Project	IEEE 802.16 Broadband Wireless Access Working Group < http://ieee802.org/16 >		
Title	Some Modifications on the Procedure of New sub-frame Creation		
Date Submitted	2006-11-10		
Source(s)	Shulan Feng Hisilicon Tech. Co., LTD Bld.17, No.8, Dongbeiwang West Road, Hai-Dian District, Beijing, P. R. China	Voice: +86-10-82829151 Fax: e-mail to: fengsl@hisilicon.com	
Re:	IEEE 802.16 Letter Ballot #24 (on P802.16h/D1) is now open		
Abstract	This contribution gives some analysis about the new sub-frame creation and suggests modifying the procedure of new sub-frame creation.		
Purpose	Modify the procedure of new sub-frame creation.		
Notice	This document has been prepared to assist IEEE 802.16. It is offered as a basis for discussion and is not binding on the contributing individual(s) or organization(s). The material in this document is subject to change in form and content after further study. The contributor(s) reserve(s) the right to add, amend or withdraw material contained herein.

Some Modifications on the Procedure of New Sub-frame Creation

Figure 1

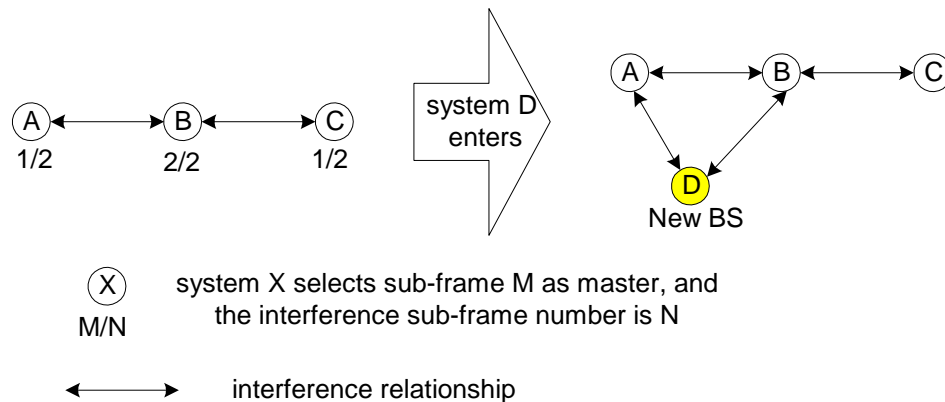
In the current 16h draft, new BS will send the request of new sub-frame creation to all member BSs of the community. Because the new BS only knows its neighbor BS, to implement this function may need some additional message. For the interference relationship shown in figure 1, when system D enters interference community, it will know system A and system B are its interference neighbors and not know the existence of system C in the same community unless the system B informs it. If the system D is requested to send requests to all member BSs in the community, system B must inform system D of the existence of system C or system B must forward the request to system C.

Figure 2

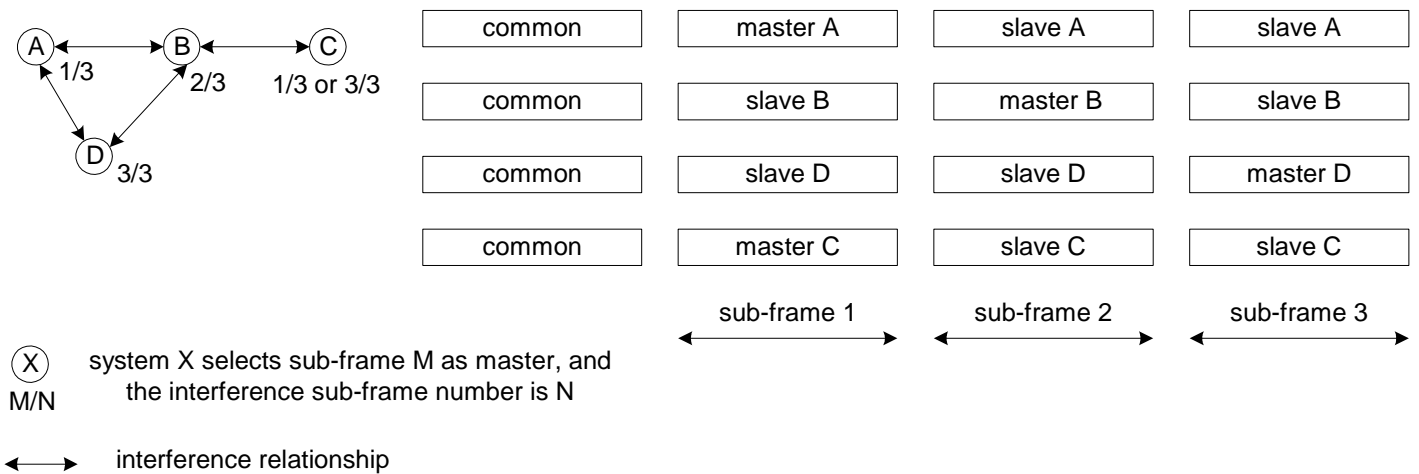
Furthermore, adding new sub-frame to all member BSs in the community may decrease the resource efficiency as shown in figure 2. In this case, and as the definition of sub-frame (15.4.2.1.2), system C may select sub-frame 1 or sub-frame 3 as its master. This is not an efficient way.

If system C selects both sub-frame 1 and sub-frame 3 as its mater, then efficiency can be improved but we must do some modifications to the current protocol, such as the information database.

Figure 3

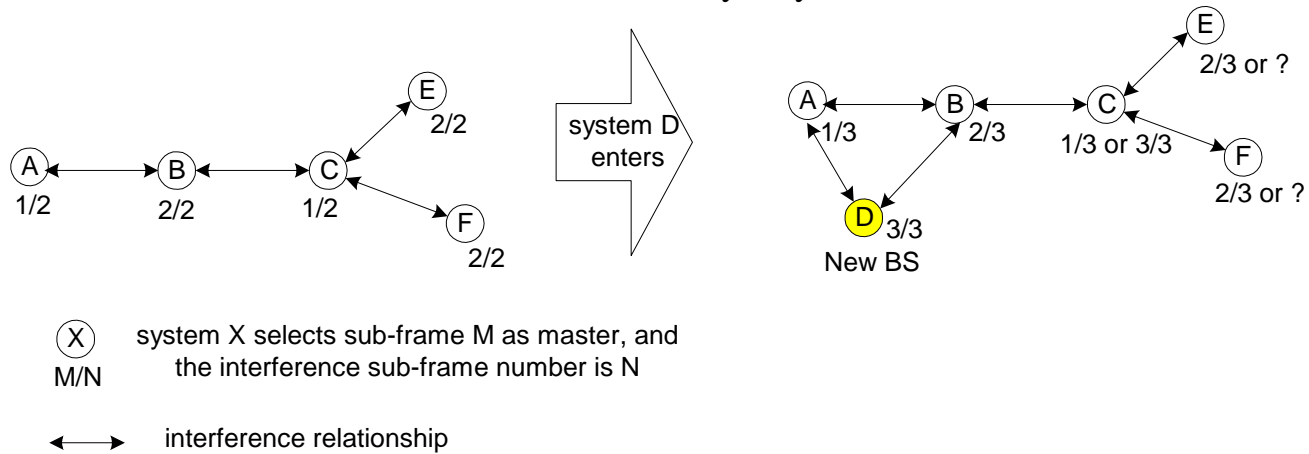
Furthermore if the interference community is more complex, then every system in the community must change its frame structure. The request message must forward to every system in the community and the coordination between systems may be intolerable. The signaling

overhead is increased and the resource efficiency may decrease.

Figure 4

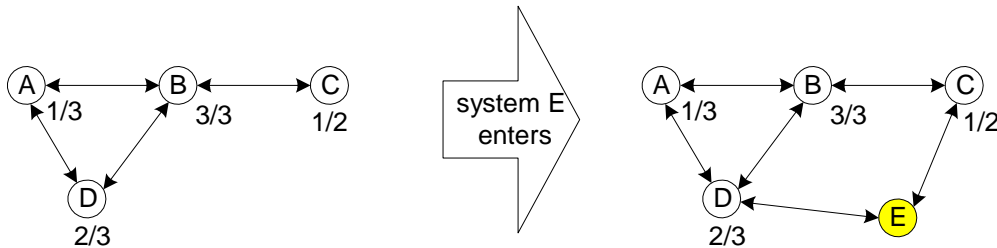
For some cases, when the sub-frame number of interference of neighbor is not same, it needs not to request all neighbor BSs to increase the sub-frame number of their own. For example, when system E enters community, it needs not to request system D to increase its sub-frame number as shown in below figure.

Figure 5

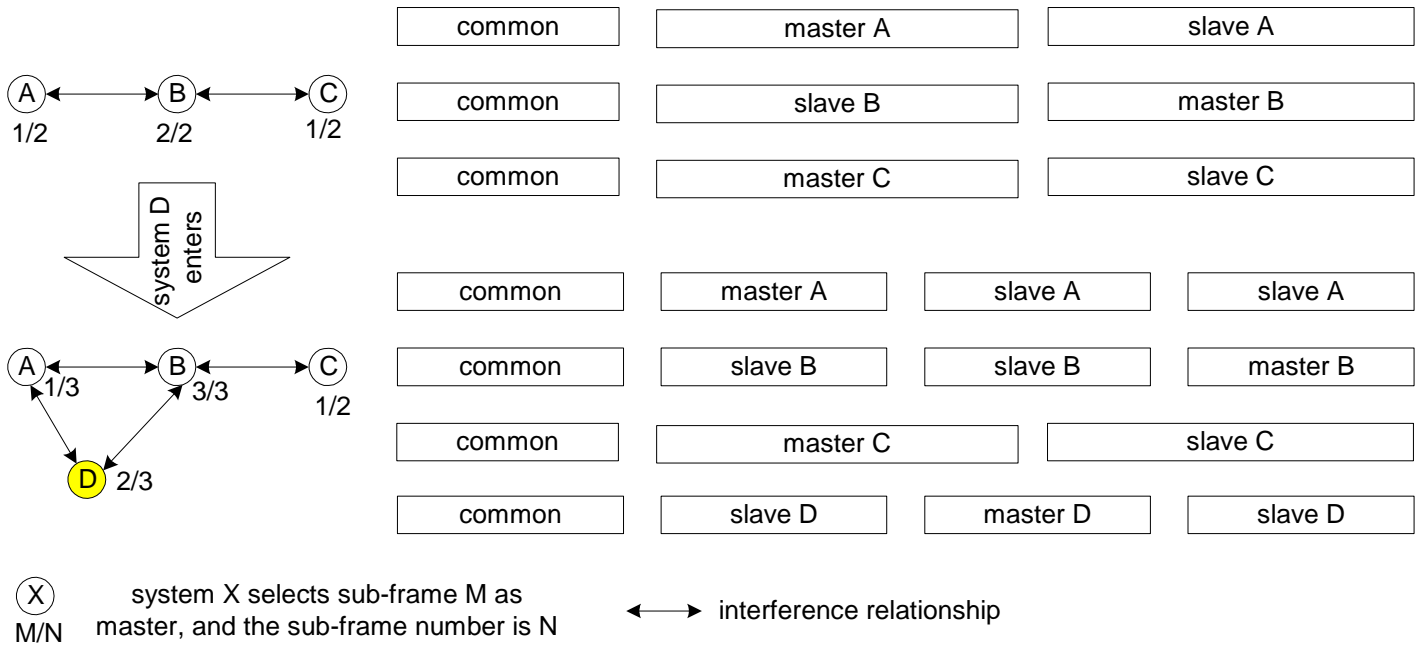
So if none of the existing sub-frames can be used, the new BS may request some of its neighbor BSs to increase their sub-frame number only. If all neighbor BSs have same sub-frame number, then the new BS may request all its neighbors to add a new sub-frame. And the BSs which have not direct interference with new BS may remain their frame structure unchanged. If the sub-frame number is not the same, then the new BS may request the neighbors which have lower sub-frame number to add new sub-frame so that all neighbors use same sub-frame number. And the BSs which have maximum sub-frame number or the BSs which have not direct interference with new BS may remain their frame structure unchanged. Figure 5, 6 and 7 give some

Figure 7

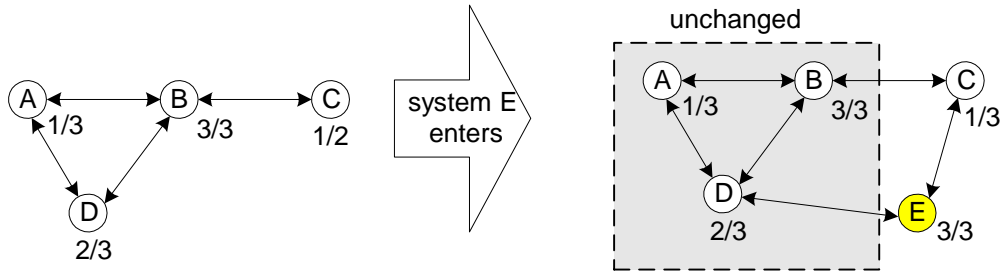
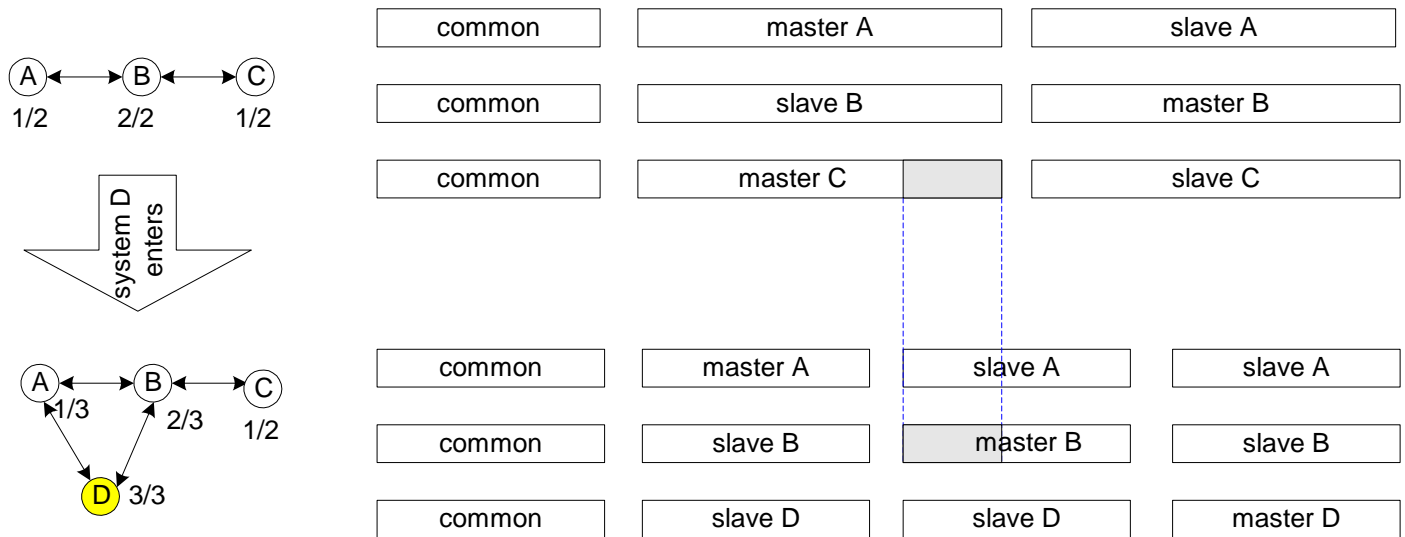
When creating new sub-frame, the master sub-frame index distribution needs to be optimized in involved BSs to avoid interference. For example, if system B selects sub-frame number 2 as its master sub-frame, then system B and system C will interference each other, as shown in below figure.
